**MONTGOMERY COUNTY HISTORIC PRESERVATION COMMISSION**  
**STAFF REPORT**

<b>Address:</b>	10013 Stoneybrook Dr., Silver Spring	<b>Meeting Date:</b>	3/22/2022
<b>Resource:</b>	1870 – 1916 Resource <b>Capitol View Park Historic District</b>	<b>Report Date:</b>	3/15/2022
<b>Applicant:</b>	Melissa Colbert	<b>Public Notice:</b>	3/8/2022
<b>Review:</b>	HAWP	<b>Tax Credit:</b>	No
<b>Case No.:</b>	1003027 REVISION	<b>Staff:</b>	Dan Bruechert
<b>Proposal:</b>	Revision to previously approved accessory structure.

The applicant proposes to construct a different gazebo than the one approved at the August 18, 2022 HPC meeting.

*Figure 2: The subject property in relation to the non-historic houses on Pratt Place. The star shows the approximate location of the proposed gazebo.*

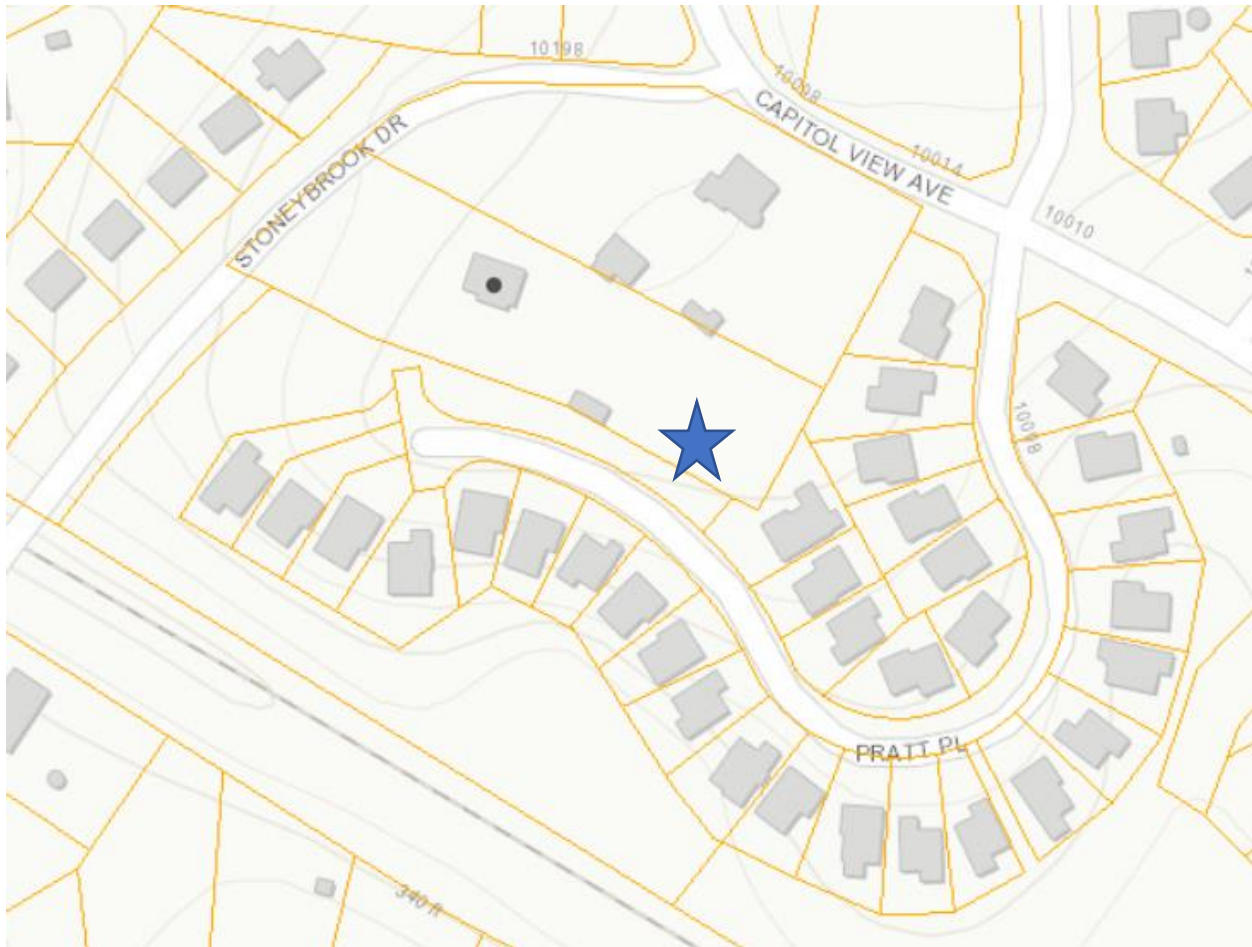
The applicant proposes to install a prefabricated 16' (sixteen foot) wide octagonal, screened-in, cedar gazebo in the southwest corner of the rear lot (the same location as the previous approval). The gazebo is just under 14' (fourteen feet) tall. The only difference from the approved gazebo is the size; materials and design match the approved gazebo. The previously approved gazebo was 12' wide.

The proposed gazebo is 1236 ft<sup>2</sup> (one thousand two hundred thirty-six square feet), which is nearly a 70% increase in total area from the 12' (twelve foot) gazebo. However, its placement in the southwest corner will be minimally visible from the public right-of-way; and the adjacent buildings are all non-contributing infill houses, constructed in 1985. Staff finds larger gazebo will not have a significant impact on the historic character of the surrounding district and recommends the HPC approve it under the same provisions as the previous approval.

Staff recommends that the Commission **approve** the HAWP application; under the Criteria for Issuance in Chapter 24A-8(b)(2) and (d), having found that the proposal will not substantially alter the exterior features of the historic resource and is compatible in character with the district and the purposes of Chapter 24A;
